Re: Northern California Power Agency Lodi Energy Center (08-AFC-10C)
Revised Petition to Amend Air Quality Conditions of Certification

Petition to Amend Air Quality Conditions of Certification for the Lodi Energy Center Project (08-AFC-10C)

Re: Application for Permit Modification
Northern California Power Agency, Lodi Energy Center
Permit No. N-2697-5-0

CO Emissions During Gas Turbine Startups
NCPA Lodi Energy Center
CO Emissions, cumulative lb
1400
1200
1000
800
600
400
200
0
0
5
10
15
20
25
30
35
Elapsed Time, minutes
11/5/2012
11/29/2012
12/2/2012
12/8/2012
12/10/2012
12/15/2012
12/22/2012
Permit Limit

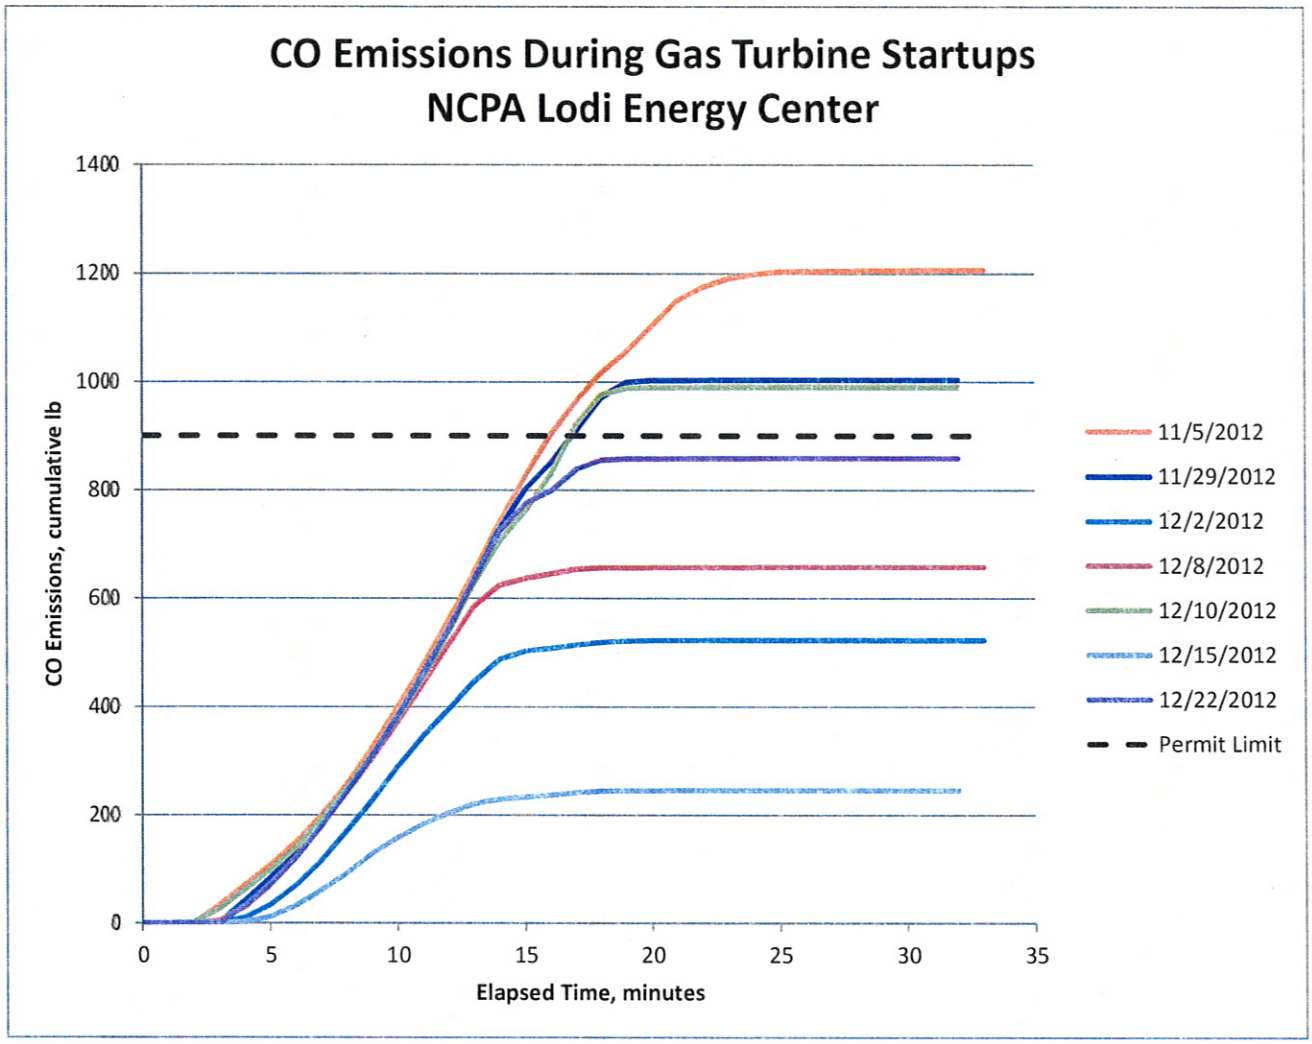
During startups, CO emissions are elevated above normal, controlled levels while the gas turbine is being brought up to full load and the oxidation catalyst control system is becoming fully effective. When the LEC gas turbine was originally permitted, the CO emission rate during startup was estimated based on startup data from other similar gas turbines. However, NCPA has found that under certain conditions (for example, very low ambient temperatures, or after the gas turbine has been shut down for many hours),

low-load CO emissions are higher than expected and the oxidation catalyst takes longer than expected to reach full control efficiency. Therefore, CO emissions during some gas turbine startups are higher than anticipated. As a result, the gas turbine cannot consistently comply with the 900 pound per hour CO limit (Condition 25) that is applicable during startup.

The attached figure shows how CO emissions from the turbine vary during startups. The highest hourly CO emission rate observed during any gas turbine startup to date is 1,207 pounds per hour. Based on this, we are requesting an increase in the maximum hourly CO emissions limit during startup to 1,500 pounds per hour, to provide a 25% compliance margin above the maximum observed emission rate.

25. *During start-up, ~~and~~ shutdown and combustor tuning periods, the emissions shall not exceed any of the following limits: NOx (as NO_2) – 160.00 lb/hr; CO – ~~900.00~~ 1500.00 lb/hr; VOC (as methane) – 16.00 lb/hr; PM10 – 9.00 lb/hr; SOx (as SO_2) – 6.10 lb/hr; or NH_3 – 28.76 lb/hr.*
